# UNITED STATES PATENT AND TRADEMARK OFFICE

APPLICATION NO.	FILING DATE	FIRST NAMED INVENTOR	ATTORNEY DOCKET NO.	CONFIRMATION NO.
10/057,229	01/25/2002	Durward S. Benham JR.	170-99-X44	3036

# Office Action Summary

### DETAILED ACTION

APU Attached to  
Turbine module

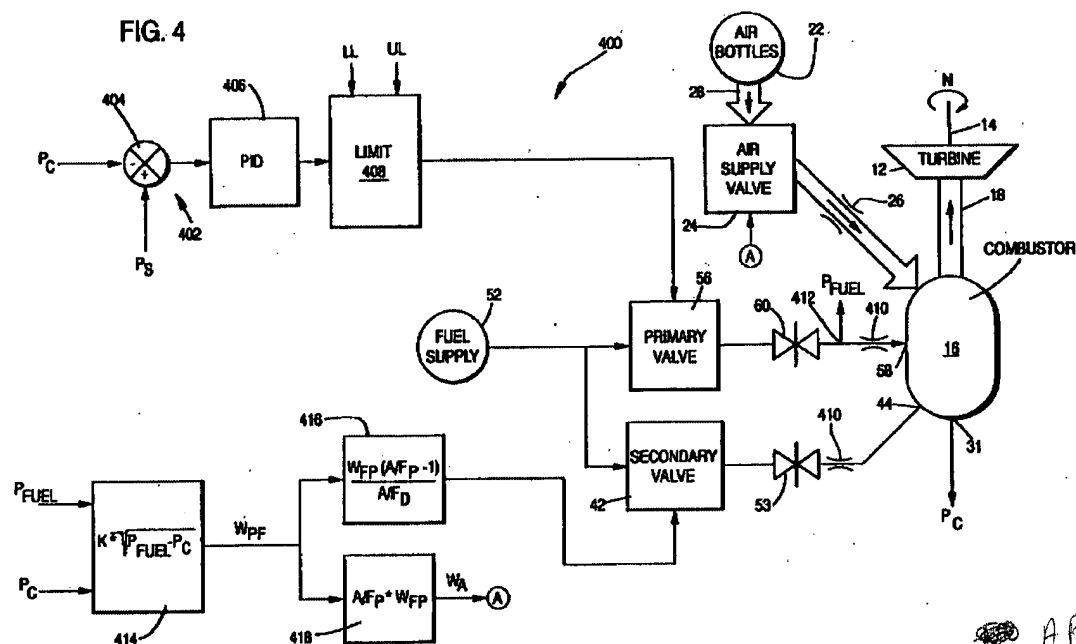
4. Claims 1, 2, 6, 7, 9, 15, 16, (17), (19) and (20) are rejected under 35 U.S.C. 102(b) as being anticipated by **Lampe et al.** (U.S patent No. 5,097,659).

5. With respect to claim 1, **Lampe et al.** teach an apparatus for generating auxiliary and emergency power. This apparatus comprises a source of pressurized air 22; a source of jet fuel 52; a turbine 12; an airflow passageway joining the source of pressurized air 22 to the turbine 12; a fuel flow passage joining the source of jet fuel 52 to the turbine 12; and a separate valve assembly 24, 26, 56, 42, 60, 53, 410 located in each flow passageway for controlling the flow of compressed air and jet fuel into the turbine. See particularly **Figure 4**; column 1 lines 7-8; and column 6 lines 10-12 of Lampe.

6. With respect to claim 2, **Lampe et al.** teach that the source of compressed air 22 comprises at least one high-pressure storage vessel. See particularly **Figure 4** and column 5 lines 20-22 of Lampe.

7. With respect to claim 6, **Lampe et al.** teach that the valve assembly located in the fuel flow passageway comprises a modulating fuel control valve 56. See particularly **Figure 4** of Lampe.

8. With respect to claim 7, **Lampe et al.** teach that the valve assembly located in the fuel flow passageway comprises a fixed orifice valve 410. See particularly **Figure 4** of Lampe.

9. With respect to claim 9, **Lampe et al.** teach an apparatus for generating auxiliary and emergency power. This apparatus comprises a source of pressurized air comprising at least one storage vessel 22; a source of jet fuel comprising a fuel tank 52; a turbine 12; an airflow passageway joining the source of pressurized air 22 to the turbine 12; a fuel flow passage joining the source of jet fuel 52 to the turbine 12; and a separate valve assembly 24, 26, 56, 42, 60, 53, 410 located in each flow passageway for controlling the flow of compressed air and jet fuel into the turbine. See particularly **Figure 4**; column 1 lines 7-8; column 5 lines 20-22; and column 6 lines 10-12 of Lampe.

10. With respect to claim 15, **Lampe et al.** teach that the valve assembly located in the fuel flow passageway comprises a modulating fuel control valve 56. See particularly **Figure 4** of Lampe.

11. With respect to claim 16, **Lampe et al.** teach that the valve assembly located in the fuel flow passageway comprises a fixed orifice valve 410. See particularly **Figure 4** of Lampe.

12. With respect to claim 17, **Lampe et al.** teach an apparatus for generating auxiliary and emergency power. This apparatus comprises a source of pressurized air comprising at least one storage vessel 22; a source of jet fuel comprising a fuel tank 52; a turbine 12; an airflow passageway joining the source of pressurized air 22 to the turbine 12; a fuel flow passage joining the source of jet fuel 52 to the turbine 12; and a modulating valve assembly 24, 26 located in the air flow passageway and a control valve 56 located in the fuel flow passageway for controlling

the flow of compressed air and jet fuel into the turbine. See particularly **Figure 4**; column 1 lines 7-8; column 5 lines 20-22; and column 6 lines 10-12 of Lampe.

13. With respect to claim 19, **Lampe et al.** teach that the control valve comprises a fixed orifice valve 410 located between the fuel tank 52 and the turbine 12. See particularly **Figure 4** of Lampe.

Figure 1.

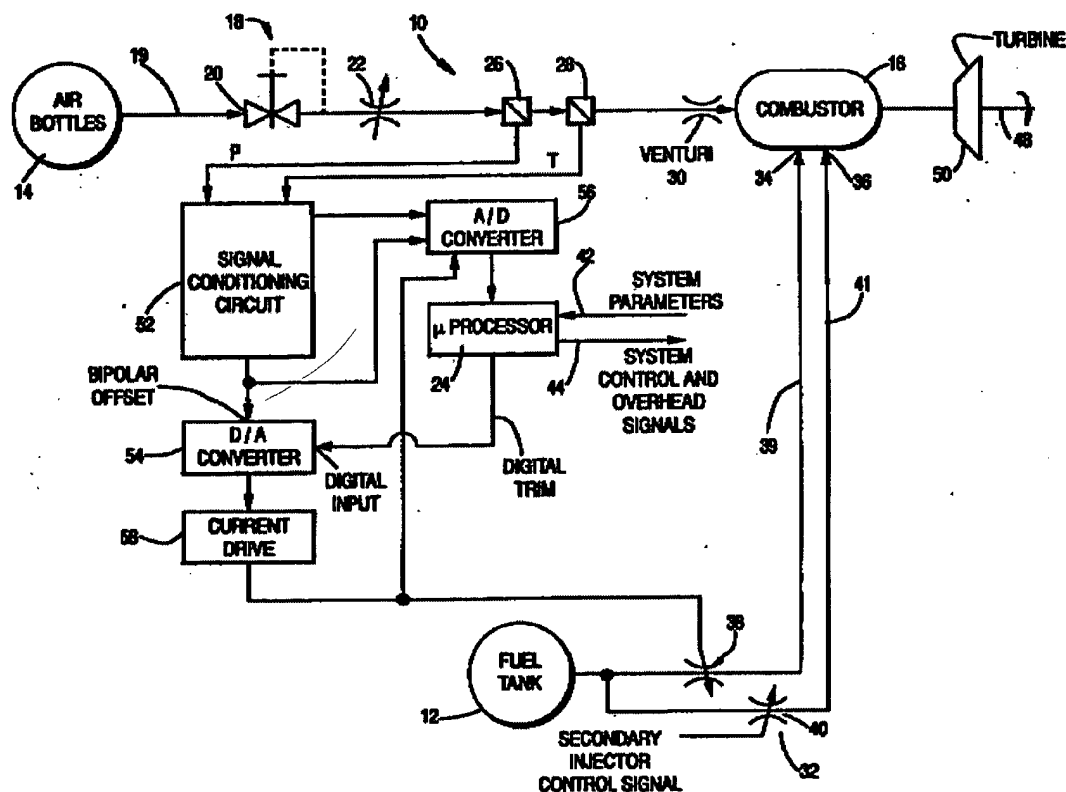
15. Claims 1, 2, 4, 5, 7, 9, 13, 14 and 16-20 are rejected under 35 U.S.C. 102(b) as being anticipated by **Lampe et al.** (U.S patent No. 5,031,398).

16. With respect to claim 1, **Lampe et al.** teach an apparatus for generating auxiliary and emergency power. This apparatus comprises a source of pressurized air 14; a source of jet fuel 12; a turbine 50; an airflow passageway joining the source of pressurized air 14 to the turbine 50; a fuel flow passage joining the source of jet fuel 12 to the turbine 50; and a separate valve assembly 20, 22, 38, 40 located in each flow passageway for controlling the flow of compressed air and jet fuel into the turbine. See particularly **Figure 1**; column 1 lines 66 to column 2 lines 1-2 of Lampe.

17. With respect to claim 2, **Lampe et al.** teach that the source of compressed air 14 comprises at least one high-pressure storage vessel. See particularly **Figure 1** and column 4 lines 1-3 of Lampe.

18. With respect to claim 4, **Lampe et al.** teach that the valve assembly located in the air flow passageway comprises a modulating air control valve 22 and a separate regulator and shutoff valve 20 located between the air control valve 22 and the source of pressurized air 14. See particularly **Figure 1** of Lampe.

19. With respect to claim 5, **Lampe et al.** teach that the valve assembly located in the air flow passageway comprises a fixed orifice valve 30 and a separate regulator and shutoff valve 20 located between the fixed orifice valve 30 and the source of pressurized air 14. See particularly **Figure 1** of Lampe.

20. With respect to claim 7, **Lampe et al.** teach that the valve assembly located in the fuel flow passageway comprises a fixed orifice valve 38. See particularly **Figure 1** of Lampe.

storage vessel 14; a source of jet fuel comprising a fuel tank 12; a turbine 50; an airflow passageway joining the source of pressurized air 14 to the turbine 50; a fuel flow passage joining the source of jet fuel 12 to the turbine 50; and a separate valve assembly 20, 22, 38, 40 located in each flow passageway for controlling the flow of compressed air and jet fuel into the turbine. See particularly **Figure 1**; column 1 lines 66 to column 2 lines 1-2 of Lampe.

22. With respect to claim 13, **Lampe et al.** teach that the valve assembly located in the air flow passageway comprises a modulating air control valve 22 and a separate regulator and shutoff valve 20 located between the air control valve 22 and the source of pressurized air 14. See particularly **Figure 1** of Lampe.

23. With respect to claim 14 **Lampe et al.** teach that the valve assembly located in the air flow passageway comprises a fixed orifice valve 30 and a separate regulator and shutoff valve 20 located between the fixed orifice valve 30 and the source of pressurized air 14. See particularly **Figure 1** of Lampe.

24. With respect to claim 16, **Lampe et al.** teach that the valve assembly located in the fuel flow passageway comprises a fixed orifice valve 38. See particularly **Figure 1** of Lampe.

25. With respect to claim 17, **Lampe et al.** teach an apparatus for generating auxiliary and emergency power. This apparatus comprises a source of pressurized air comprising at least one storage vessel 14; a source of jet fuel comprising a fuel tank 12; a turbine 50; an airflow passageway joining the source of pressurized air 14 to the turbine 50; a fuel flow passage joining the source of jet fuel 12 to the turbine 50; and modulating valve assembly 20, 22, 30 located in the air flow passageway and a control valve 38 located in the fuel flow passageway for

controlling the flow of compressed air and jet fuel into the turbine 50. See particularly **Figure 1**; column 1 lines 66 to column 2 lines 1-2 of Lampe.

26. With respect to claim 18, **Lampe et al.** teach that the valve assembly located in the air flow passageway comprises a modulating air control valve 22 and a separate regulator and shutoff valve 20 located between the air control valve 22 and the source of pressurized air 14. See particularly **Figure 1** of Lampe.

27. With respect to claim 19, **Lampe et al.** teach that the valve assembly located in the fuel flow passageway comprises a fixed orifice valve 38. See particularly **Figure 1** of Lampe.
